3 MW HYDRO POWER PROJECT BY DARJEELING POWER PVT. LTD.

Project Title	3 MW Hydro Power Project by Darjeeling Power Pvt. Ltd.
Version	02
Report ID	VKU.VER.11.22_VCS 1739

Report Title	3 MW Hydro Power Project by Darjeeling Power Pvt. Ltd.
Client	EKI Energy Services Limited
Pages	52

Upon plotting the data where the PLF was plotted month wise for the 4 years the following graph was obtained

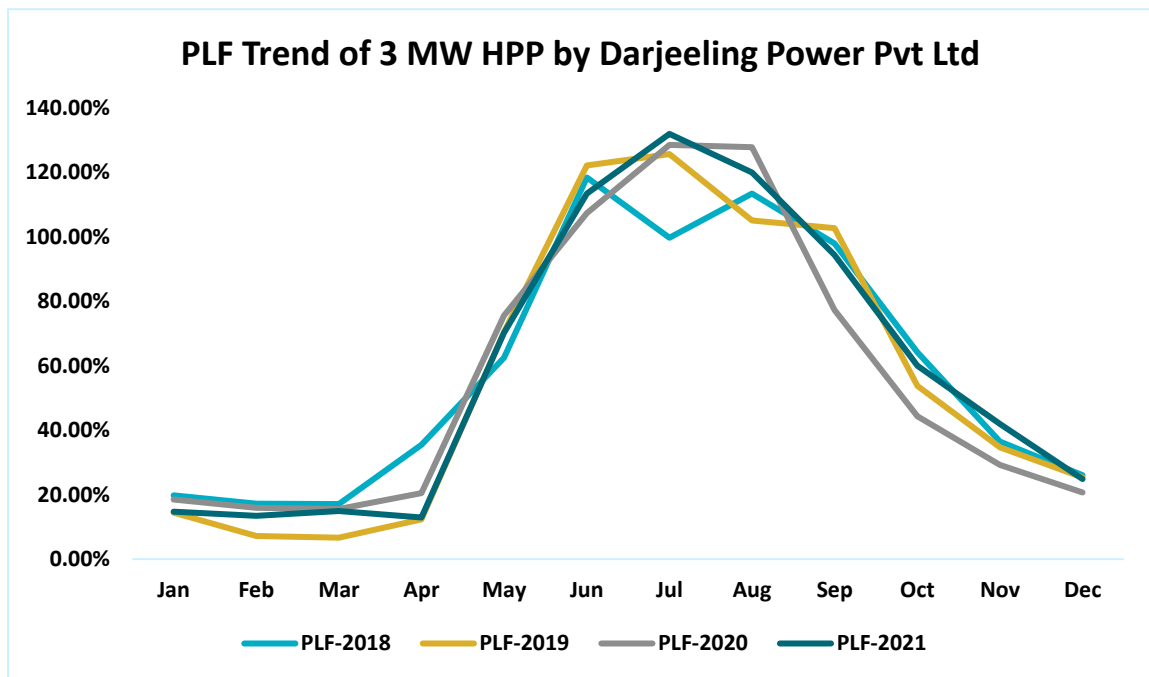
6. PP is requested to explain how PLF achieved for the full years of the monitoring period ie., 2018, 2019, 2020, 2021 are 59.04%, 56.73%, 56.80% and 59.43% respectively. This is lower than the PLF mentioned in registered PD and validation report of 71%. PP is requested to clarify how this is consistent with the IRR and sensitivity analysis conducted at the time of validation which was performed for PLF between +/- 10% of 71%.

Assessment team has verified the revised ER sheet and the monitoring report where PP has stated the PLF achieved by the plant over the entire monitoring period of 4 years and 2 months from 02-January-2018 to 28-February-2022 (Inclusive of both dates). Upon thorough review of the data by the assessment team in section 4.4 of this report it was confirmed that PLF varies for the monitoring period years due to various factors that are beyond the control of the PP, primarily due to immoderate water flow during summers when PLF peaks up during May, June, July and August months. The PLF exceeds 100% in these months while barely achieving 20-25% in the rest of the months. Hence, the average PLF achieved during this monitoring period of 58% is due to factors beyond the control of the PP and is lower than the PLF considered in the registered Joint VCS PD&MR which is acceptable.
